TO: Missoula Planning Board

RE: Rebecca Donnelly Proposed 17-Lot Subdivision, East End of Landon's Way (Parcel ID

04209305123050000)

ABOVE: View west on Woodbine Place looking toward Hillview Way. Snow area impacting parking along south side of street.

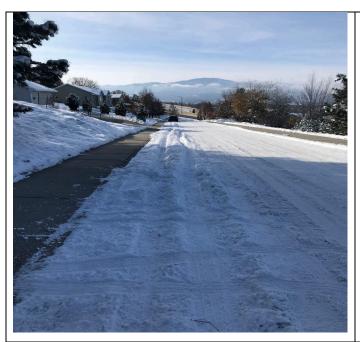
It is a road safety issue and I believe it is a direct result of previously approved subdivision conditions for Mountain Shadows West Subdivision, Phase 2. The approved road width for Woodbine Place, from Hillview Way to the intersection of Landon's Way & Woodbine, is too narrow for wintertime travel AND that is with the current traffic loads on this stretch of Woodbine Place. I have taken photos and they are attached to this letter. These photos clearly show the reason for my concerns. I personally took these photos and will attest they have not been altered or doctored in any way. The road width is barely acceptable in non-snow load times of the year. Even though there are "No Parking" signs to the north side of the street, that is not enforced and can be an issue when vehicles are parked on both sides of the street.

Now, introduce snow into the road safety equation. Neighbors plow snow from driveways onto the shoulder areas of the street, both sides. This further reduces the navigable width of this road. My photos show there to be an approximate 4' of road width impacted by plowed snows. Sometimes this is 4' on both sides of the street and other times it is slightly less but during the winter months, there is an average of 6' of paved road width that is eliminated by this accumulated snow. Further, take the south side of Woodbine Place, where onstreet parking is allowed, and you will see one parked car, an 8- foot separation and then my vehicle. I have not distorted distances. My vehicle is only 2' from the sidewalk on the north side of Woodbine Place. As a result, the current road incorporates a traffic safety concern. Neighbors have managed to "make do" but that is based on current traffic loads.

ABOVE: Same view west toward Hillview Way with 8' of separation between parked car and my personal vehicle.

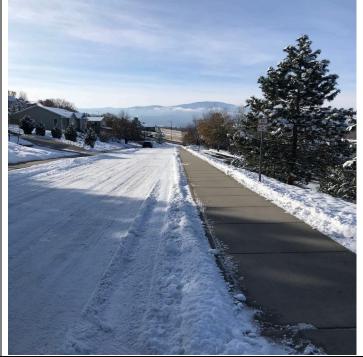
ABOVE: View showing my personal vehicle with south side parked car with distance from my vehicle to sidewalk on north side of Woodbine.
